UNITED STATES OF AMERICA
NUCLEAR REGULATORY COMMISSION

In the Matter of:)	Docket No. 72-22-ISFSI
PRIVATE FUEL STORAGE, LLC)	ASLBP No. 97-732-02-ISFSI
(Independent Spent Fuel)	
Storage Installation))	August 9, 1999

STATE OF UTAH'S STATEMENT OF MATERIAL FACTS
IN DISPUTE REGARDING UTAH CONTENTION R

Figure 14

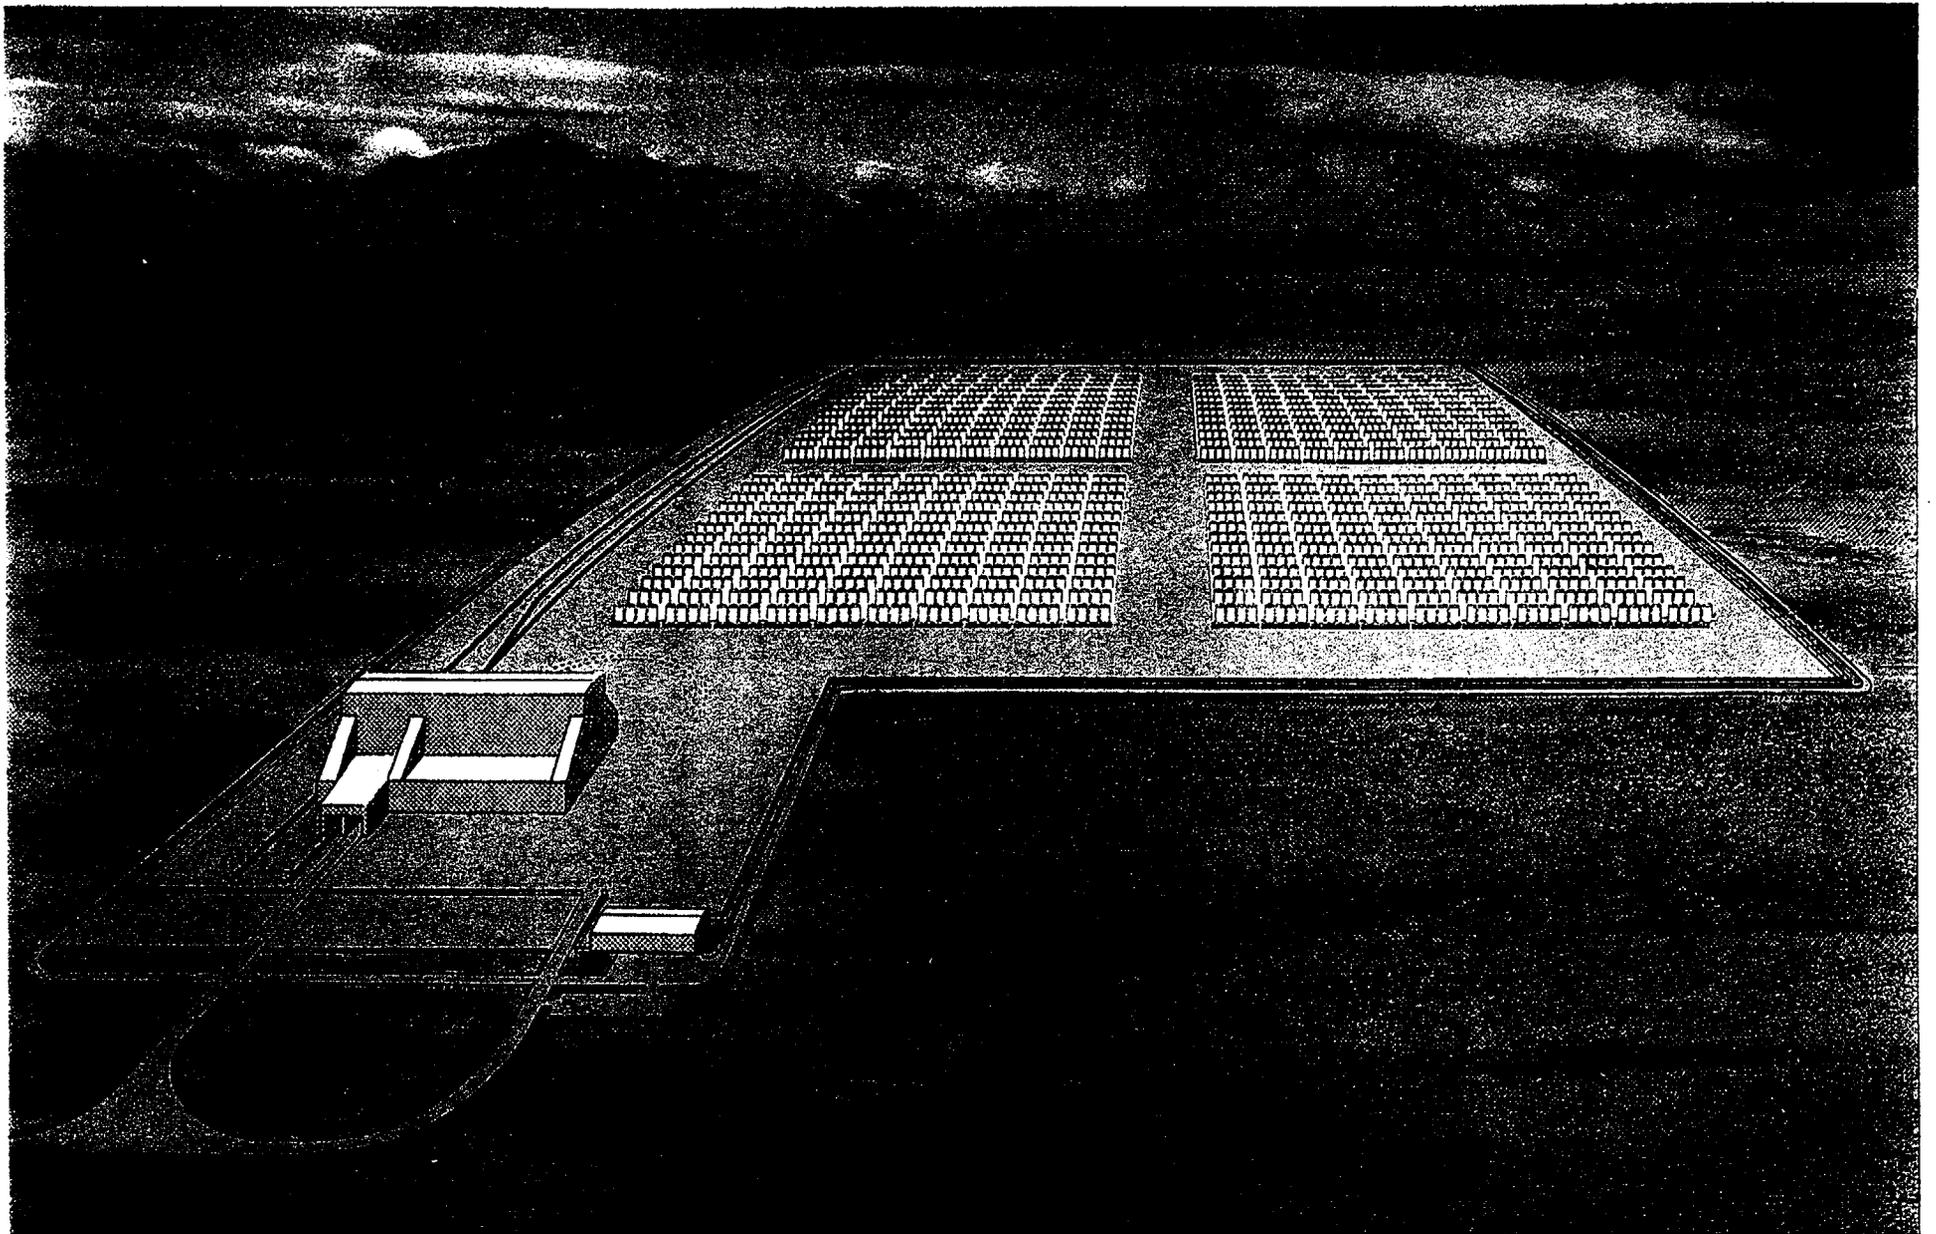
20. Figures 8 and 14 attached in support of Applicant's RAI response 14-1 dated February 8, 1999, show that railroad tracks enter and exit the Canister Transfer Building. See Attachment A to this Statement of Facts; see also, SAR Fig. 4.7-1
